Access Compliance Report

Public Rights-of-Way

Intersection ID: 31882	Main Street: STOWE_DERBY_DR	Cross Street: CENTERLINE_DR	Location: SE
ADA ID: 71F43F46AD1A	Ramp Type: PerpDiag	Initial Pass/Fail: Fail	Overall Compliance: No
Severity Score: 21.25			
Codes/Mitigation Info/Possible Solution		Field Measurements/Component Compliance

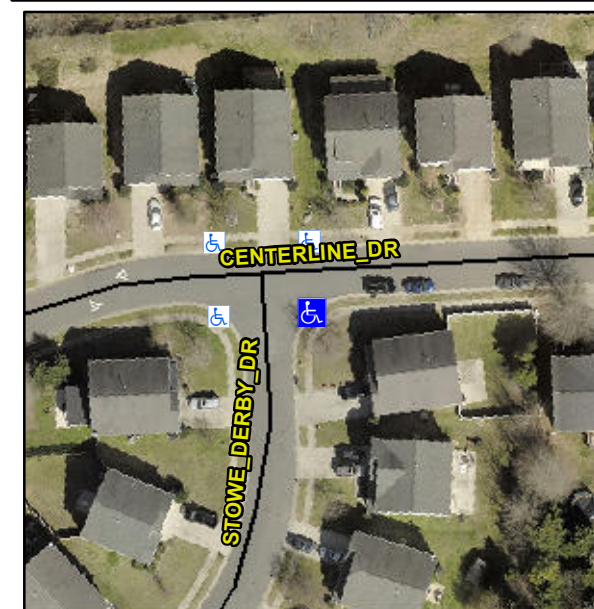
R304.5.1, R304.5.3

Compliance	Description	Data	Compliance	Description	Data
N/A	Ramp Length (in)	49.0	Yes	Ramp Slope (%)	7.2
No	Ramp Width (in)	38.5	No	Ramp XSlope (%)	5.6
N/A	Flare Type LT	N/A	N/A	Flare Type RT	N/A
N/A	Flare Slope LT (%)	N/A	N/A	Flare Slope RT (%)	N/A
N/A	Flare Traversable LT?	N/A	N/A	Flare Traversable RT?	N/A
N/A	Landing Length (in)	N/A	N/A	DWS Provided?	N/A
N/A	Landing Width (in)	N/A	N/A	DWS Contrast?	N/A
N/A	Landing Slope (%)	N/A	N/A	DWS Length (in)	N/A
N/A	Landing X Slope (%)	N/A	N/A	DWS Full Width?	N/A
N/A	Landing Curb? (Y/N)	N/A	N/A	DWS Offset (in)	N/A
N/A	Shared Landing?	N/A			
N/A	Gutter Ponding?	N/A	N/A	Gutter Slope (%)	N/A
N/A	Gutter Lip Ht (in)	N/A	N/A	Gutter X Slope (%)	N/A
N/A	Painted X Walk1?	No	N/A	Painted X Walk2?	No
	X Walk 1 Direction	To N		X Walk 2 Direction	To W
N/A	X Walk 1 Width (in)	N/A	N/A	X Walk 2 Width (in)	N/A
	X Walk 1 Slope (%)	2.2		X Walk 2 Slope (%)	1.0
	X Walk 1 X Slope (%)	3.9		X Walk 2 X Slope (%)	0.9

Remove & Replace Curb Ramp With Two New Directional Ramps or Equivalent.
